**Town of Kittery
Planning Board Meeting
December 14 2023**

ITEM 5—17 and 25 US Route 236—Major Site Plan — Final Review

Action: Approve plan or continue review. Geoff Aleva, on behalf of owner/applicant 25 & 17 Route 236 LLC, is proposing to develop a 35-unit rooming house and associated parking shared with an existing 7-unit apartment on the properties of 25 and 17 Route 236, Tax Map 21 Lot 20 & Map 20 Lot 12, in the Route 236 Commercial (C-2) Zone.

ENLARGED SITE PLAN

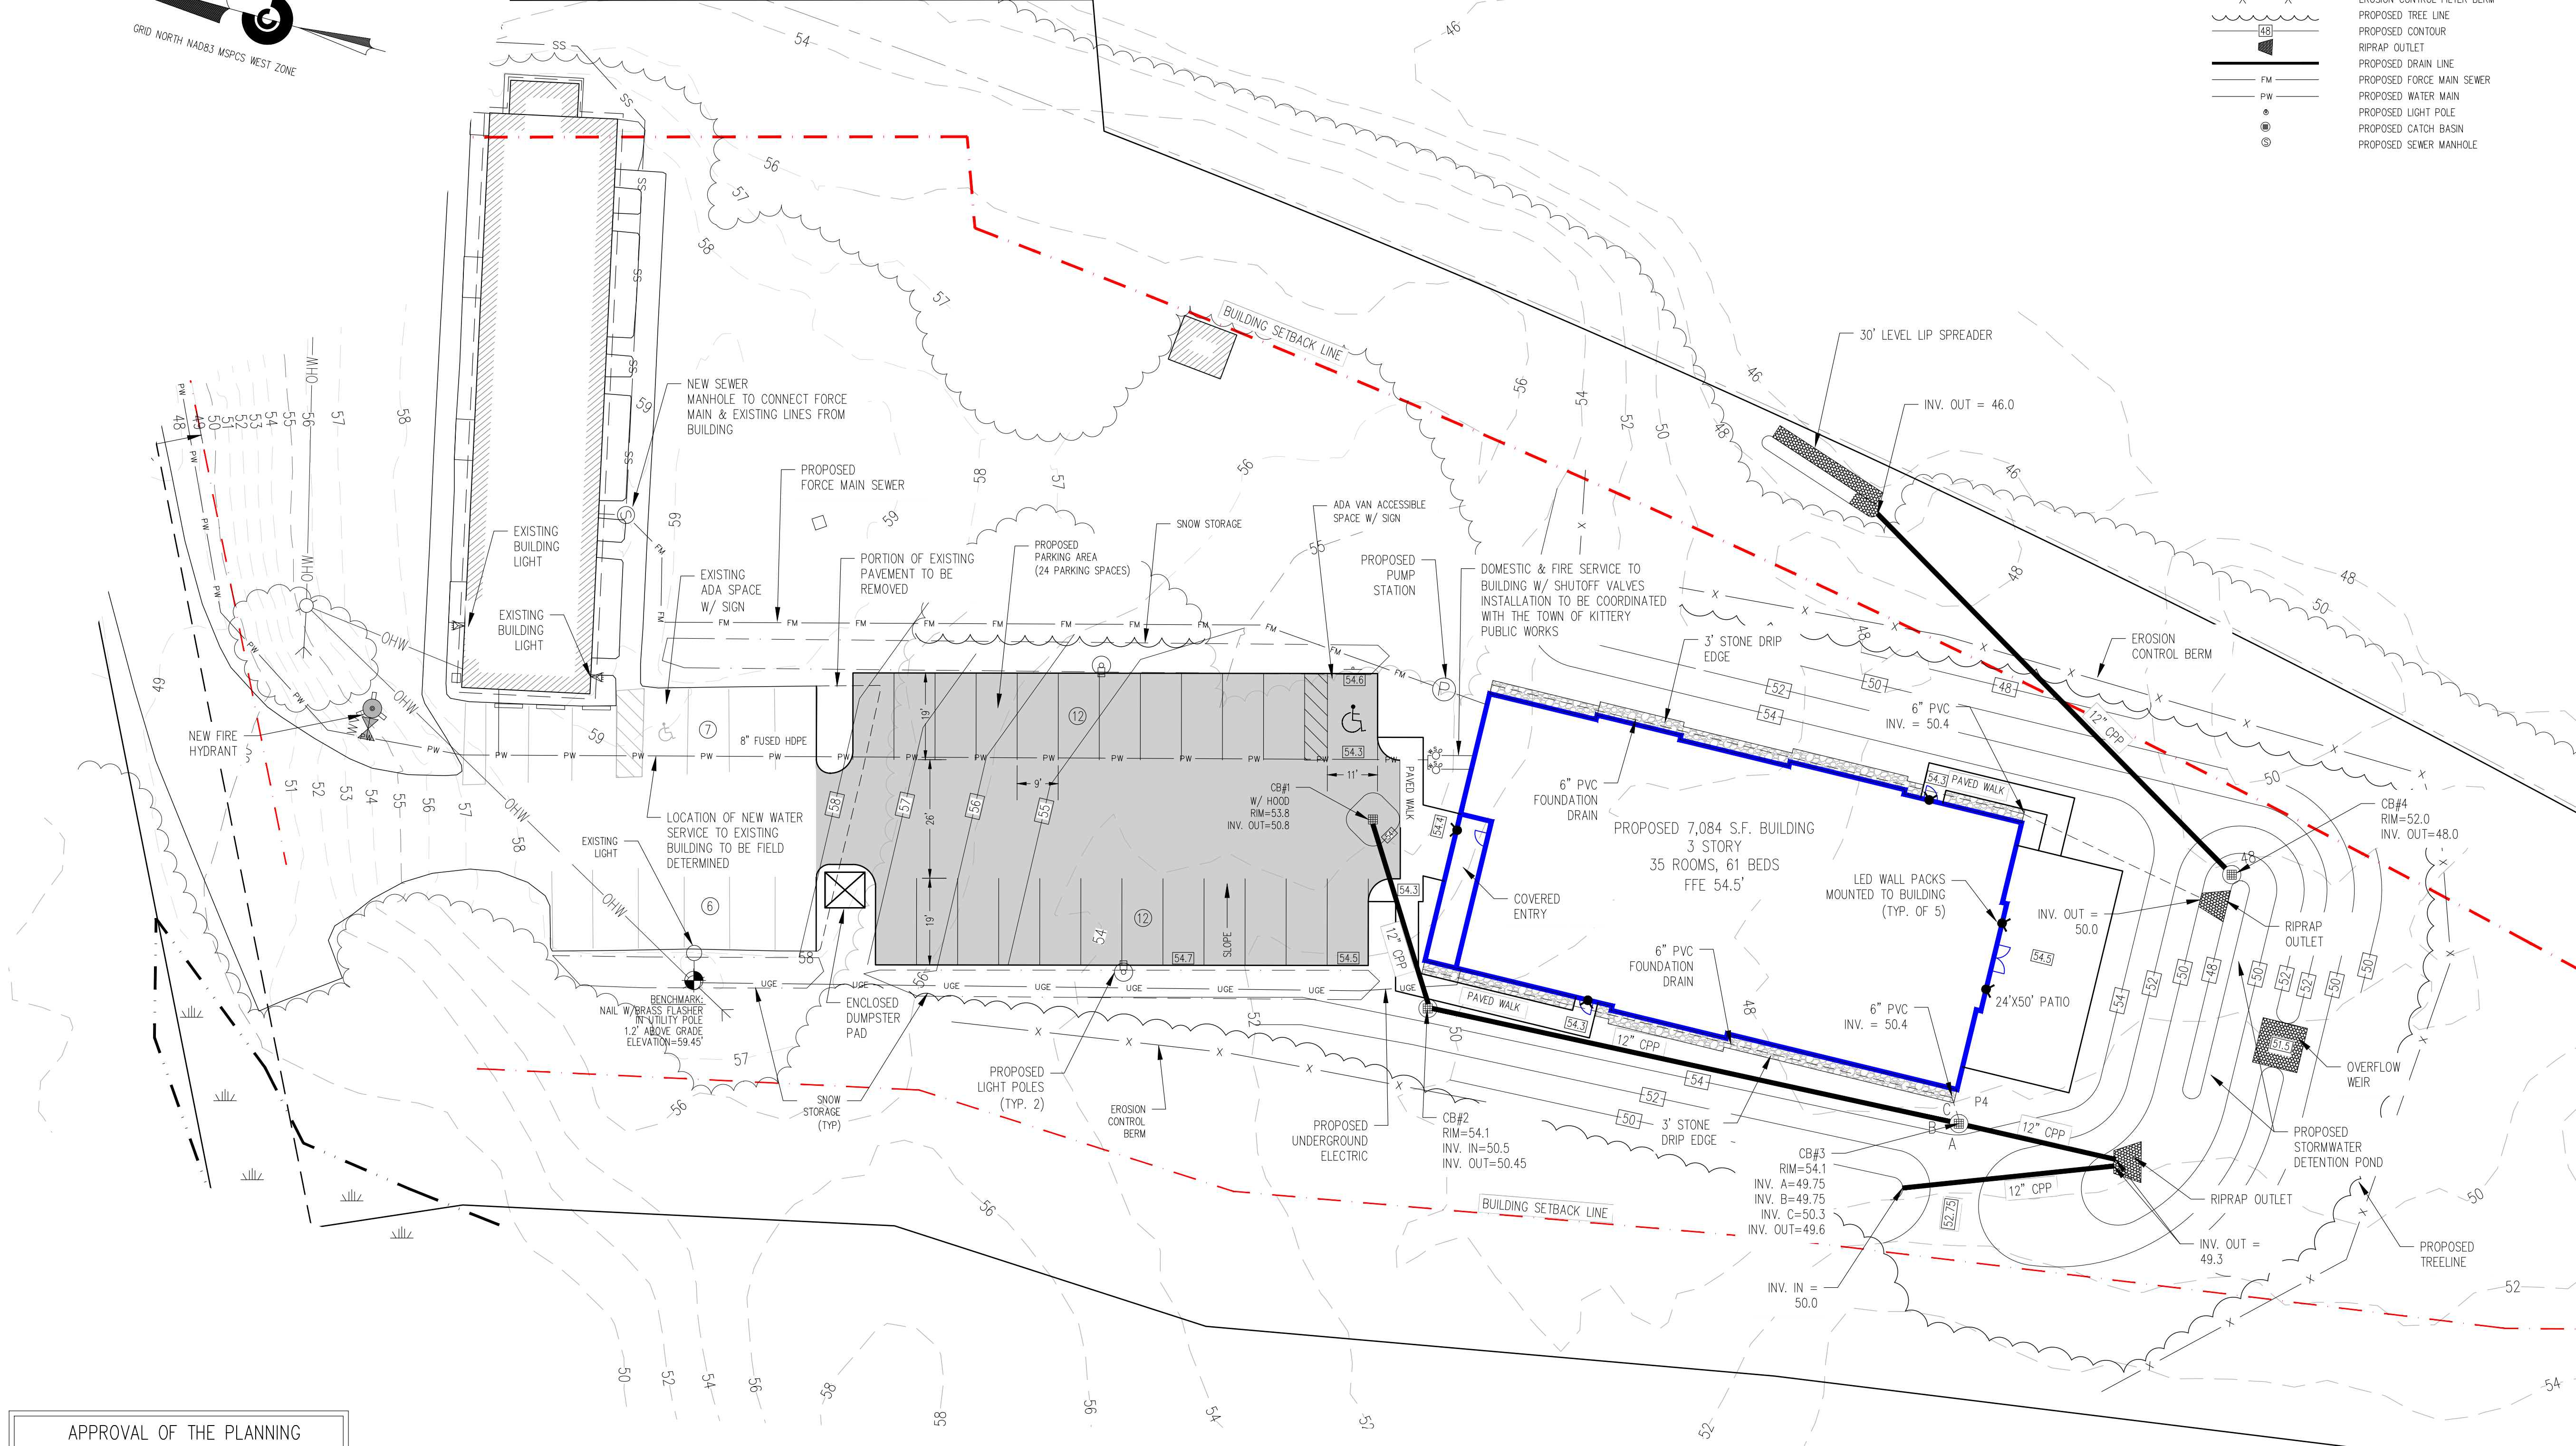
3. Following feedback from the Technical Review Committee, the applicant has added a fire hydrant next to the apartment building in the proposed plan, to provide adequate emergency service access to the entire lot.

SITE LIGHTING PLAN

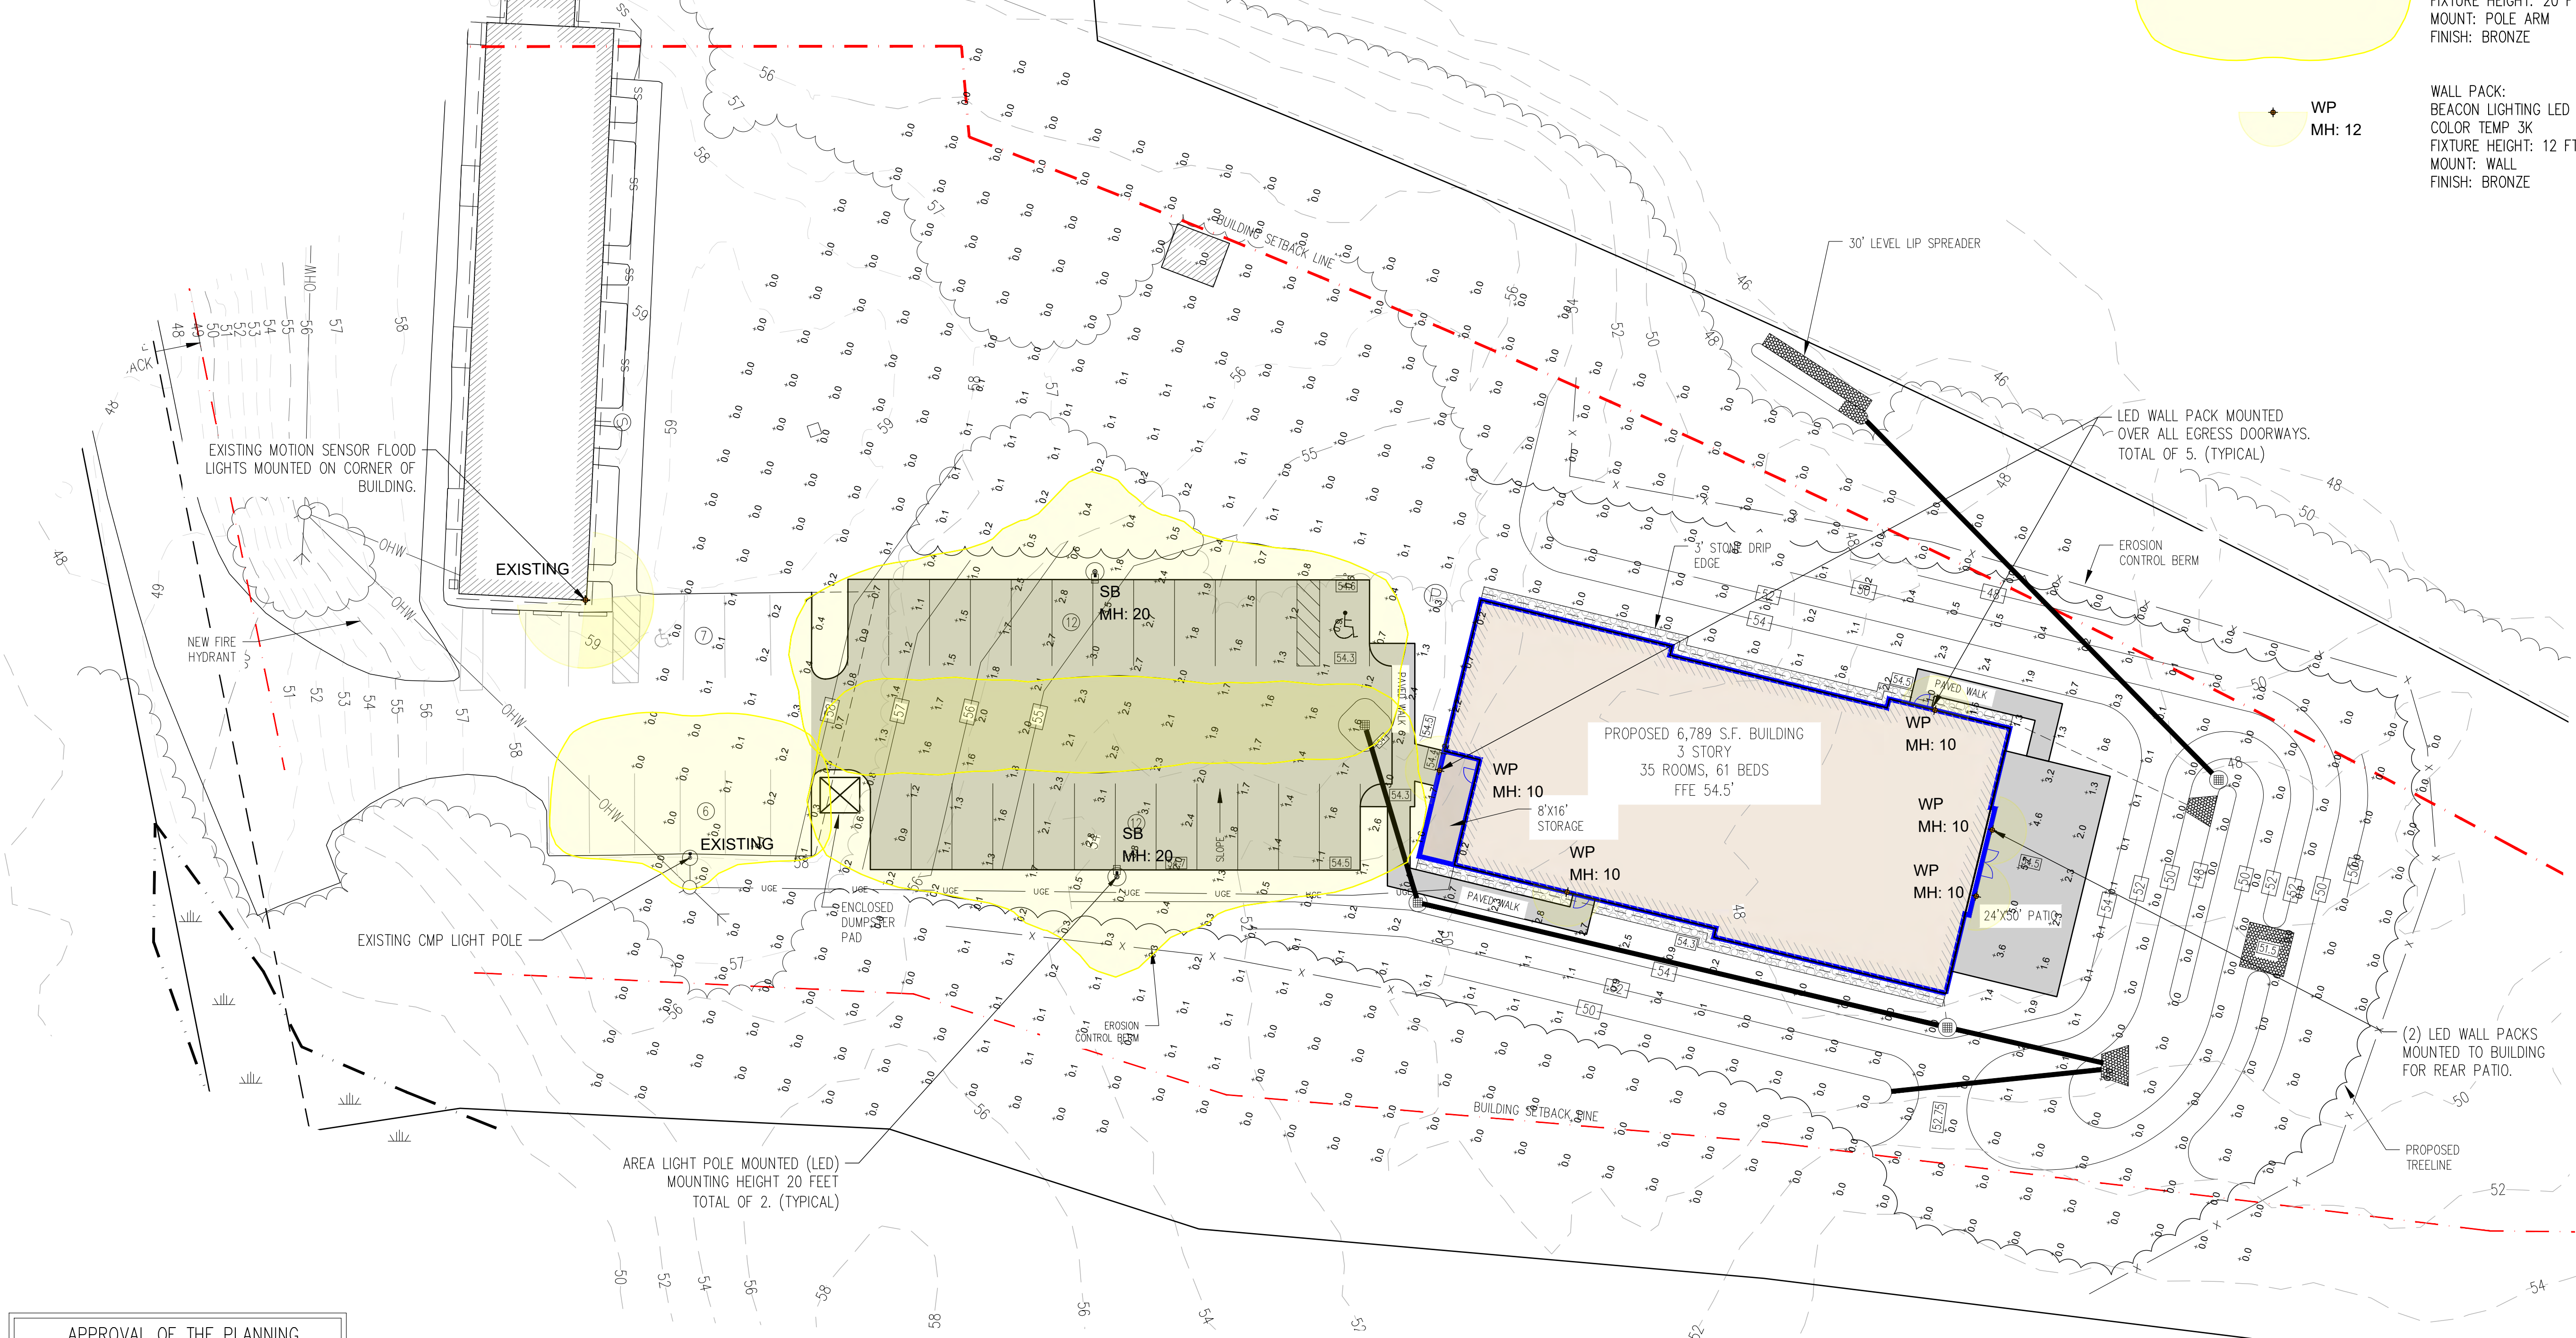
On October 26th, the planning board accepted the preliminary site plan application as complete, then scheduled a site walk on November 9th and a public hearing on November 16th. After the public hearing, the planning board approved all requested waivers, and granted preliminary approval, on the condition that the final plan set and photometric plan is reviewed by a third-party engineer before final approval is granted. Review from the third-party engineer is anticipated to be completed on December 11th. Staff suggest the planning board discuss the submitted photometric plan and determine if the plan is ready for final approval.

Finding: The proposed development will be utilizing existing public utilities for the building. The proposed lighting plan will meet the standards set by Town Code.
